**CITY OF BEAVERTON
DESIGN EXCEPTION REQUEST**

G:\PDX_Projects\19\2519 - Beaverton Non-Potable Program\CAD\Sheets\19-2519-OR-C.dwg FIG 1 4/9/2021 4:12 PM LEA.CONNORS 23.0s (LMS Tech)

SITE PLAN

FIG 1

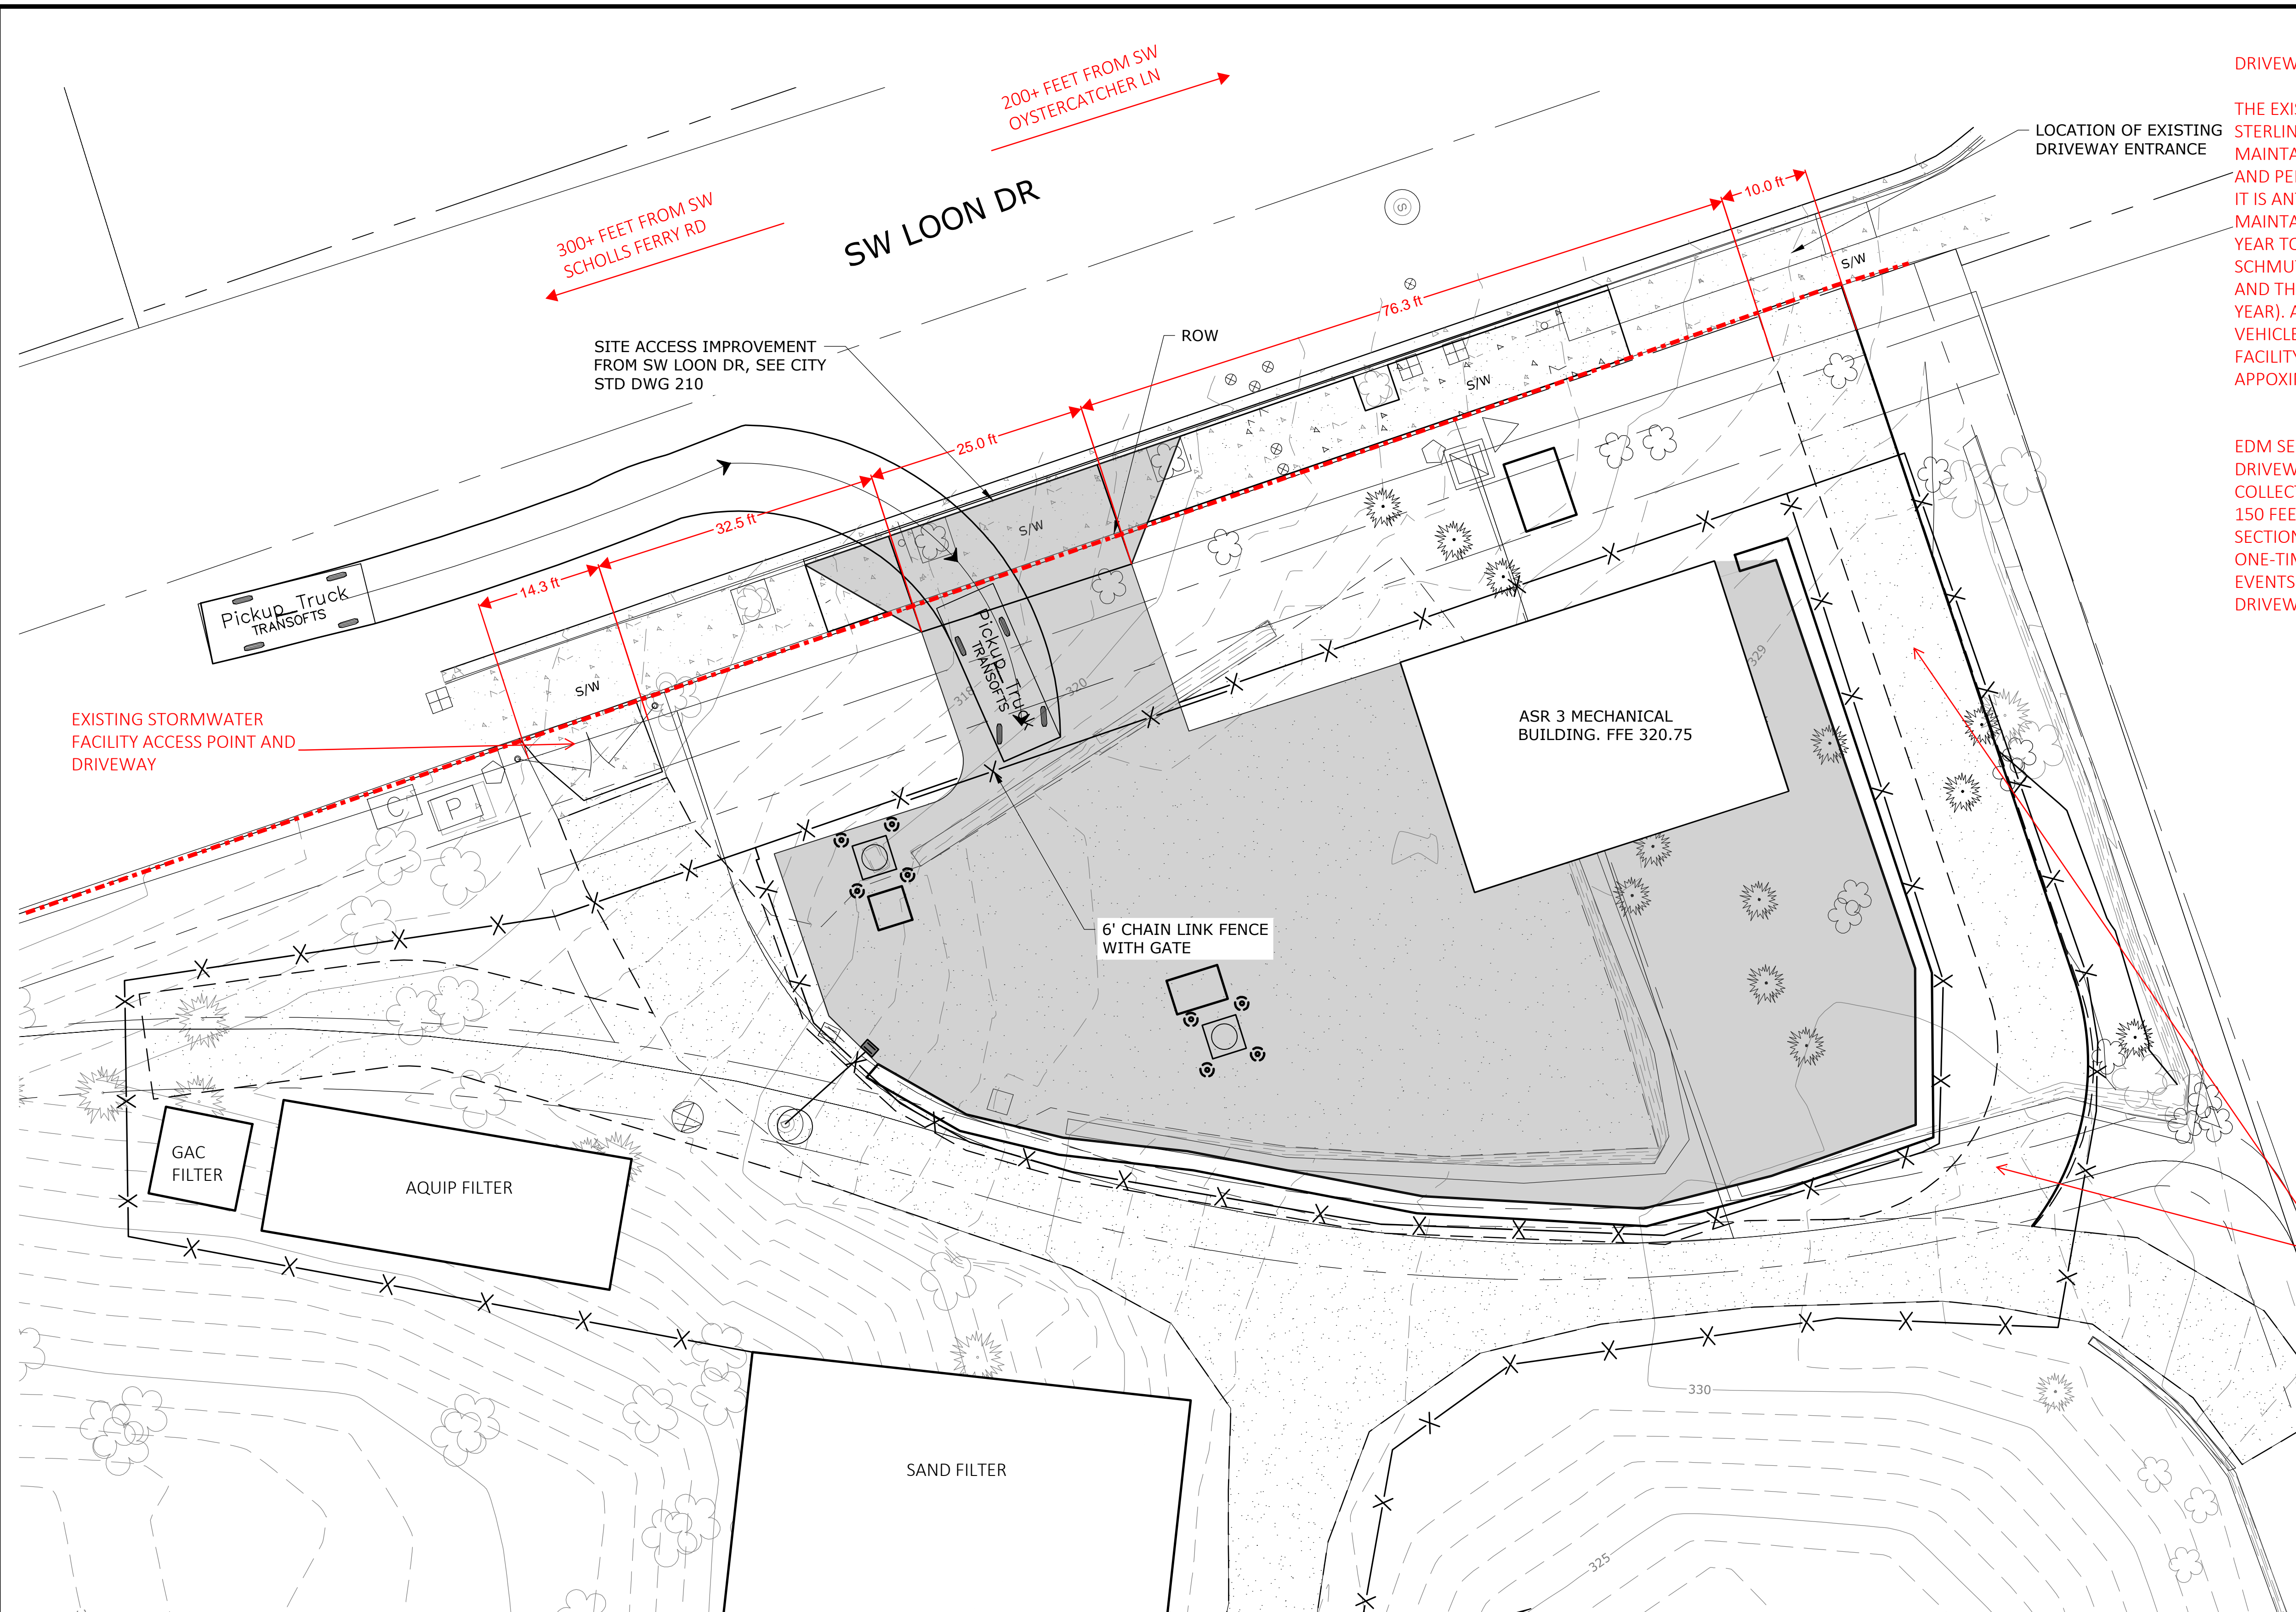
THE EXISTING DRIVEWAYS (NORTH AND SOUTH) FOR ACCESS TO STERLING PARK STORMWATER FACILITY ARE PROPOSED TO BE MAINTAINED AS ACCESS POINTS TO THE STORMWATER FACILITY AND PERIODIC ACCESS TO THE STERLING PARK TREATMENT SYSTEM. IT IS ANTICIPATED THAT THE DRIVEWAYS WILL ONLY BE USED TO MAINTAIN THE TREATMENT SYSTEM TWO OR THREE TIMES PER YEAR TO SERVICE THE SAND FILTER (REMOVAL OF TOP LAYER OR SCHMUTZDECKE), AQUIP FILTER (REPLACE MEDIA, ONCE PER YEAR) AND THE GAC FILTER (GRANULAR ACTIVATE CARBON, ONCE PER YEAR). ALL OTHER MAINTENANCE ACTIVITIES WILL NOT REQUIRE VEHICLE ACCESS VIA THESE DRIVEWAYS. THE PROPOSED ASR FACILITY ACCESS DRIVEWAY WILL BE USED TO ACCESS THE SITE APPROXIMATELY 3 TIMES PER WEEK UNDER NORMAL OPERATIONS.

EDM SECTION 210.21.C AND E REQUIRES CORNER CLEARANCES OF DRIVEWAYS AND DRIVEWAY SPACING ON ARTERIALS AND COLLECTORS WITH 25 MPH DESIGN SPEED TO BE A MINIMUM OF 150 FEET. IN ACCORDANCE WITH THE CITY OF BEAVERTON EDM SECTION 160.1.A, WE REQUEST THAT THE CITY APPROVE A ONE-TIME EXCEPTION TO THE CITY STANDARD GIVEN THE RARE EVENTS FOR ACCESS AND USE OF THE NORTH AND SOUTH DRIVEWAY ACCESS POINTS.
